FINAL REPORT

HIGH LEVEL BRIDGE PEDESTRIAN AND CYCLING SAFETY REVIEW

AUGUST 2016

PREPARED FOR
CITY OF EDMONTON

Figure 3: High Level Bridge Typical Cross-Section
Source: City of Edmonton High Level Bridge Tender Drawings

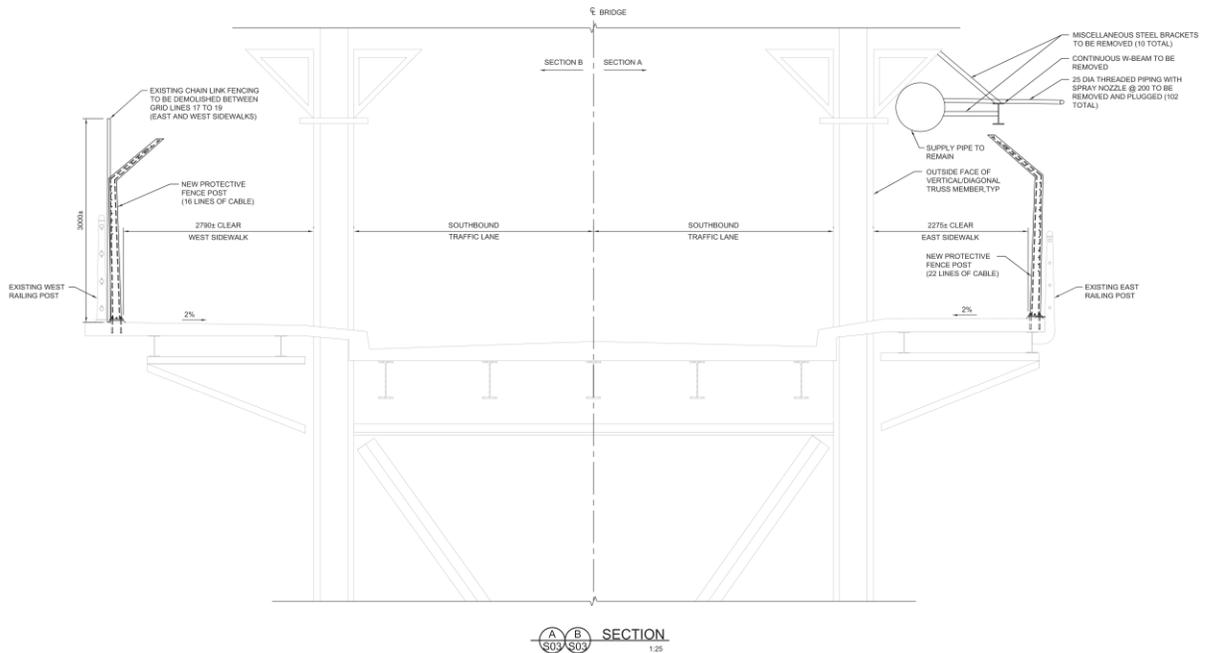
The installation of the protective fences has resulted in a reduction of the width of the pathways on both the east and the west sides of the bridge by approximately 0.3 metres.

According to the design drawings provided by the City of Edmonton, the resulting typical width of the east side pathway is currently approximately 2.3 metres between the outside face of the vertical/diagonal truss members and the new protective fence posts (**Figure 9**). Widths were confirmed with on-site measurements. The east side pathway is further narrowed at two specific locations with additional obstructions, reducing the width to as narrow as 1.8 metres at these constrained locations (this issue is discussed in further detail below in **Issue 3**).

According to the design drawings, the resulting typical width of the west side pathway is currently approximately 2.8 metres between the outside face of the vertical/diagonal truss members and the new protective fence posts. Widths were confirmed with on-site measurements. The west side pathway is further narrowed at the south end of the bridge deck at the approach to the transition to 109 Street NW (this issue is discussed in further detail below in **Issue 3**).

Given the existing conditions, to ensure the safe operation of the pathways, it is suggested that the pathway operations be modified, and it would be desirable that the resulting operations and widths would be in accordance with the Guide, i.e. meeting minimum design guidelines.

Figure 11: Location of Obstructions and Pinch Points

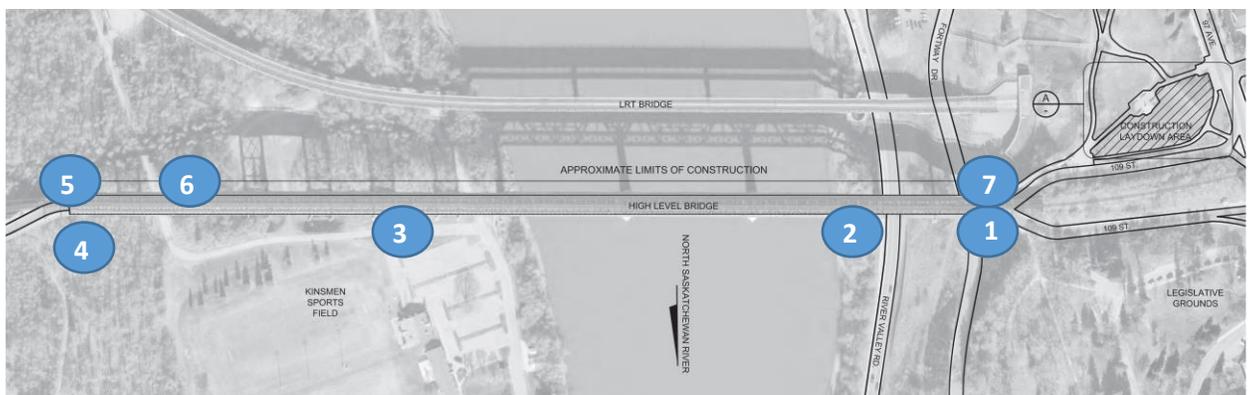
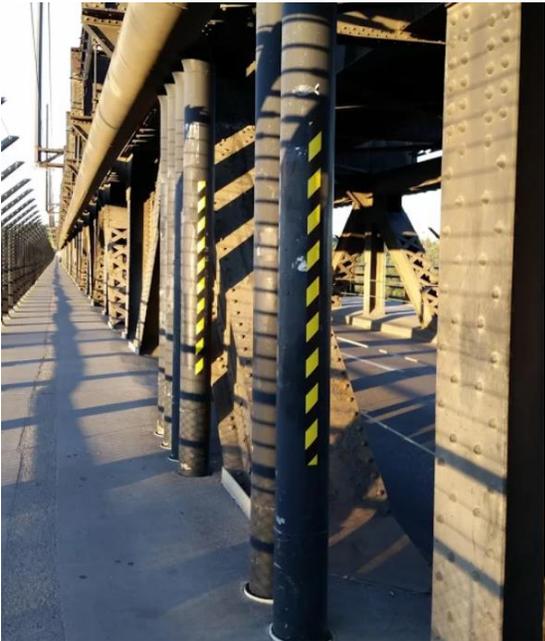
As noted previously, the typical width of the pathways are 2.8 metres on the west side and 2.3 metres on the east side based on the cross-section drawings provided. However, there are several pinch points along the pathways which have constrained widths. The location of these obstructions and pinch points can be seen in **Figure 11** and are illustrated in photos below. At each of these locations the pathway narrows, creates an obstruction for pathway users, and is a potential safety hazard.

Location 1: East Side – North Entry/Exit

Location 2: East Side – Waterfall Piping

Width: 1.8 metre (Source: City of Edmonton)

Location 3: East Side - Bridge Column

Width: 2.0 metres hand rail to face of the new post
(Source: City of Edmonton)

Location 4: East Side – South Bridge Entry/Exit

Width: 2.0 metres (Source: City of Edmonton)

Location 5: West Side – South Entry/ Exit

Width: 2.9 m at the narrowest

Location 6: West Side - Bridge Column and Vertical Obstructions

Width and Openings:

Vertical Height - 2.3 metres

Pathway width on either side of the bridge columns - 1.2 metres and 1.7 metres

Location 7: West Side – North Entry/ Exit

- Install reflective hazard markings on all obstructions.
- Consider the installation of obstruction pavement markings as outlined in TAC guidelines.
- Consider installing additional warning signage at pinch points, ensuring the location of the signage does not create an additional obstruction but informs users that pathway narrows and to slow down and use caution.
- Consider adding advance warning signs for pinch points.
- Consider removing where applicable the metal barrier located on the southeast approach pathway to provide some additional width (as seen in the photos for **Location 4**).

Figure 12: High Level Bridge at Night (West Side)

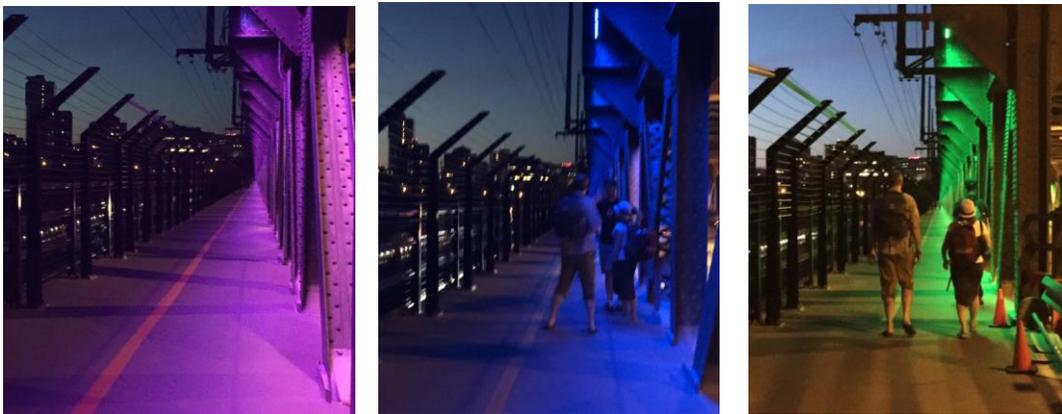
Like speeding, lighting and personal safety concerns were identified in the incident reports collected through the Edmonton Bicycle Commuters Survey. Lighting of the pathway specifically could help to illuminate obstructions and jogs in the pathway itself. Additional lighting could also help enhance personal safety and visibility in the evening. At the time of the evening site visit the lighting on the bridge deck was rotating colours and thus brightness. While this was visually appealing, it was found that depending on the colour of the lights being used pathway visibility varied (**Figure 12**).

- Consider installing additional pedestrian scale overhead lighting where feasible on the bridge pathway itself ensuring that any additional light does not obstruct the pathway itself.

Figure 17: South End/West Side Parallel Multi-Use Pathway

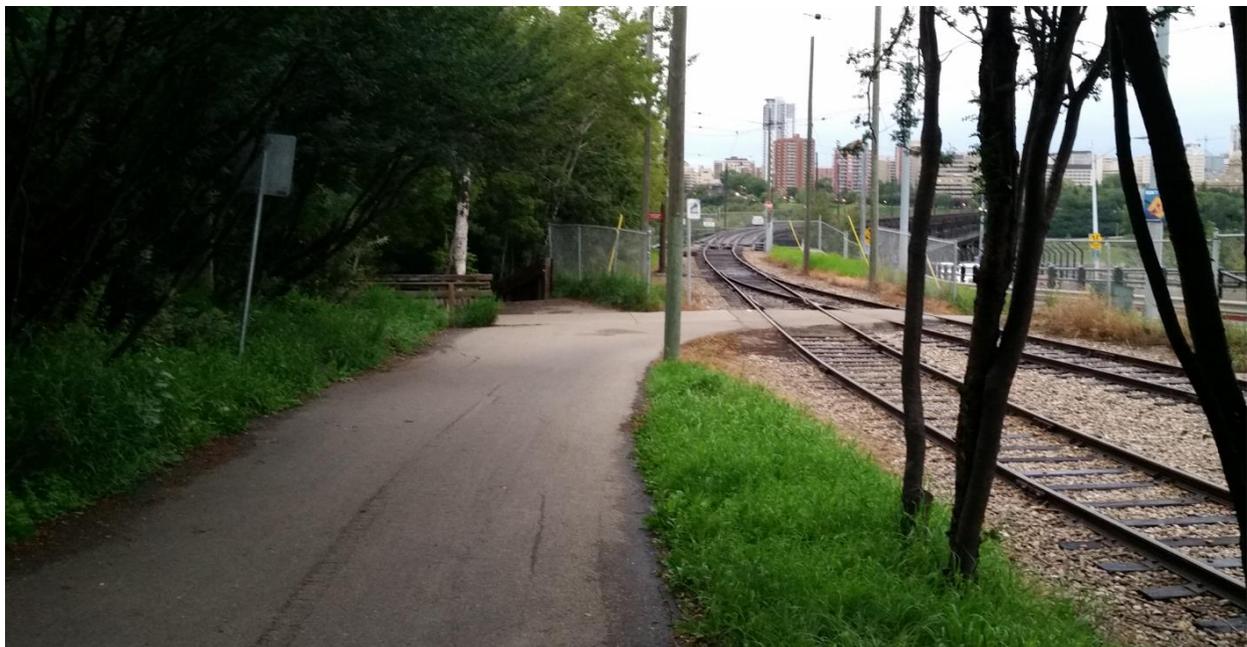
The pathway south of the bridge on the west side is currently being used as a shared use pathway with two-way operations (**Figure 16** and **Figure 15**). The current width of this pathway does not meet TAC's minimum width guidelines. Further, the pathway is confined by a fence separating the pathway from the rail tracks. However on this side of the bridge approach, there is no fence separating people walking and cycling from motor vehicles. Some utilities are also located within the pathway, resulting in further constraints at some locations. This lack of separation could create a situation where if a person walking or cycling were to lose control and fall off of the pathway they could be struck by moving motor vehicles. There is a shared use pathway that runs parallel to the narrower sidewalk (**Figure 17**). The limited lighting, overgrown vegetation and lack of visibility from the street can make this route less appealing due to personal safety concerns, resulting in more people cycling on the narrower pathway.

- Consider widening the west side pathway, subject to structural, geotechnical and/or property constraints. This may require working with other stakeholders to acquire additional space from the rail right-of-way if required.
- Consider installing a guard rail to prevent pedestrians and cyclists that fall from being struck by moving motor vehicles (**Figure 18**)
- Consider providing more lighting and additional vegetation maintenance on the designated multi-use pathway that runs parallel to the roadway on the west side of the bridge.

Figure 27: North Side Intersection Permitted Movements

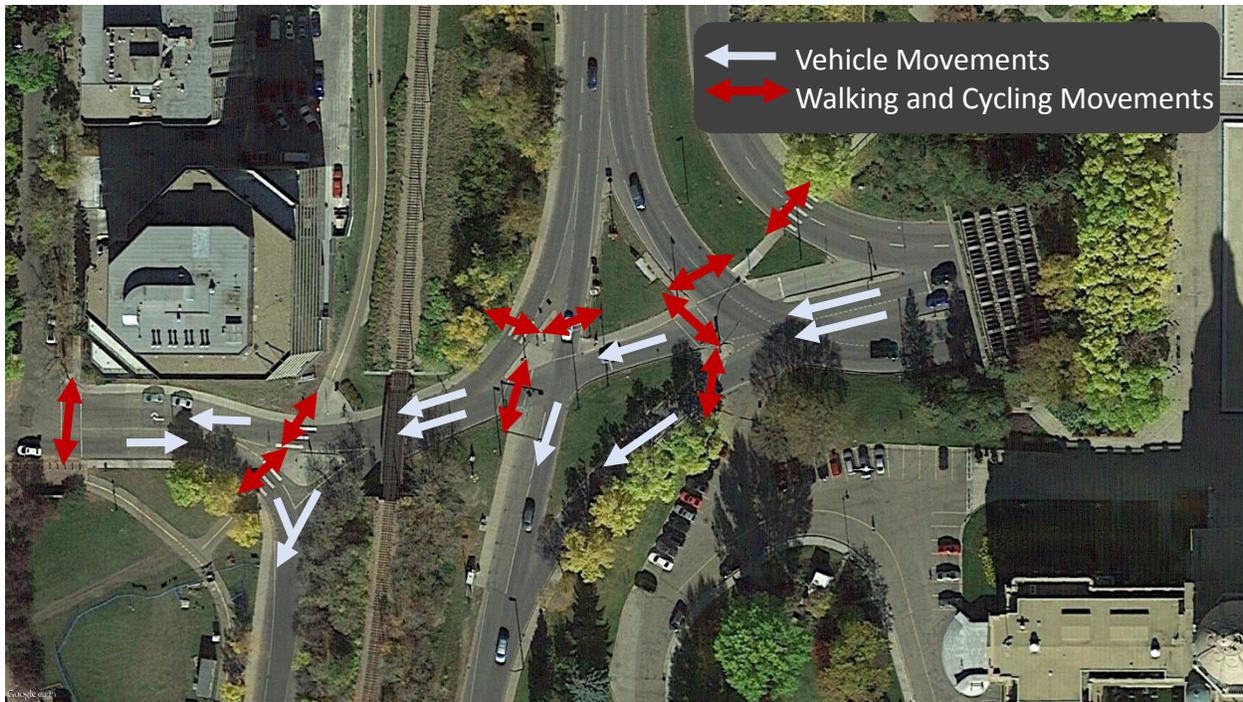
As seen in **Figure 27** below, there are a number of intersections that a person walking or cycling needs to cross to access the connections on either side of the bridge. People walking and cycling are sharing the sidewalk and crosswalk space, which can be uncomfortable and pose a safety risk to both user groups. It is also unclear if people cycling are permitted to share the sidewalks and crosswalks with people walking, as existing signage indicates that the shared use facility designation ends and there are no multi-use crossing (elephant's feet) markings or signage permitting cycling at crosswalks (**Figure 26**).

The number of times a person walking or cycling needs to cross motor vehicle travel lanes also results in additional time spent waiting and may result in more risky behaviours. Each additional crossing also increases the risk of conflict between motor vehicles. This will be exacerbated if usage is restricted on the east side pathway and without enhancements to the intersections on the north side of the bridge there is the potential of higher rates of non-compliance of the restrictions.

- Provide guidance on how people cycling should be travelling through the intersection. If crosswalks are multi-use, consider using elephant's feet pavement markings to designate this as a shared space. However, over the long term, it is suggested that crossings for people walking and cycling are separated and additional space is provided at refuge islands to avoid conflict, particularly if the volume of users increases.

Figure 29: South Side Intersection Permitted Movements

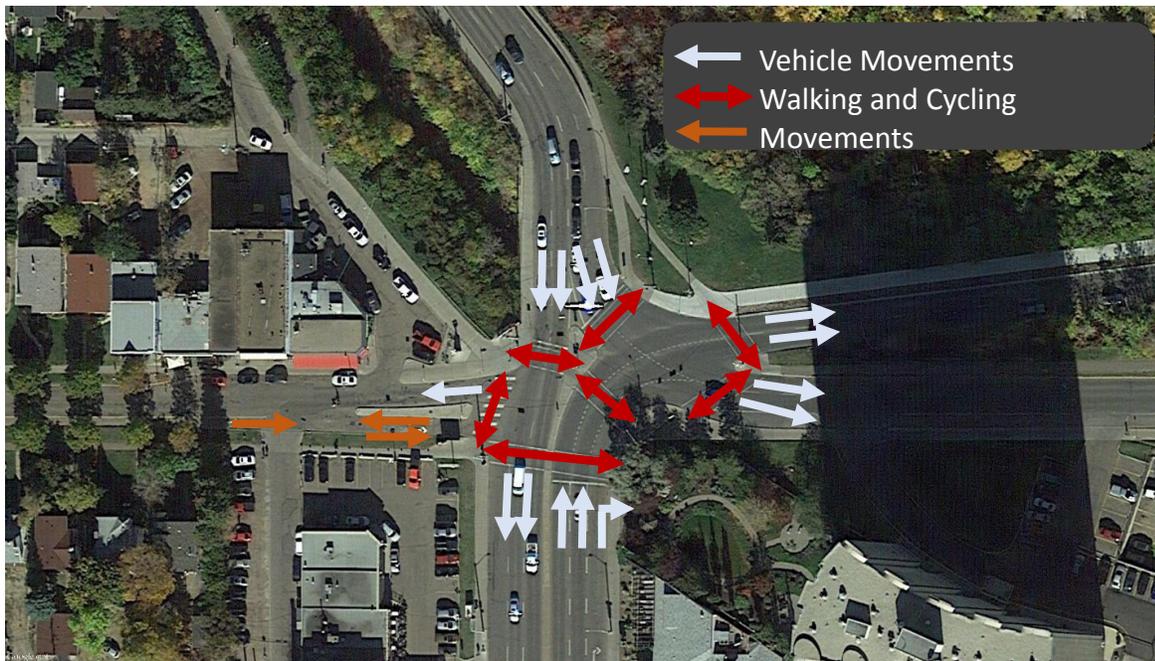
Similarly to the north side, there are a number of different ways people walking and cycling can access the different sides of the bridge as seen in **Figure 29**. While not as complex as the intersections on the north side, the crosswalks and refuge islands still are functioning as a shared space for people walking and cycling and can create confusion as well as space constraints as both users are travelling through the intersection (**Figure 30**).
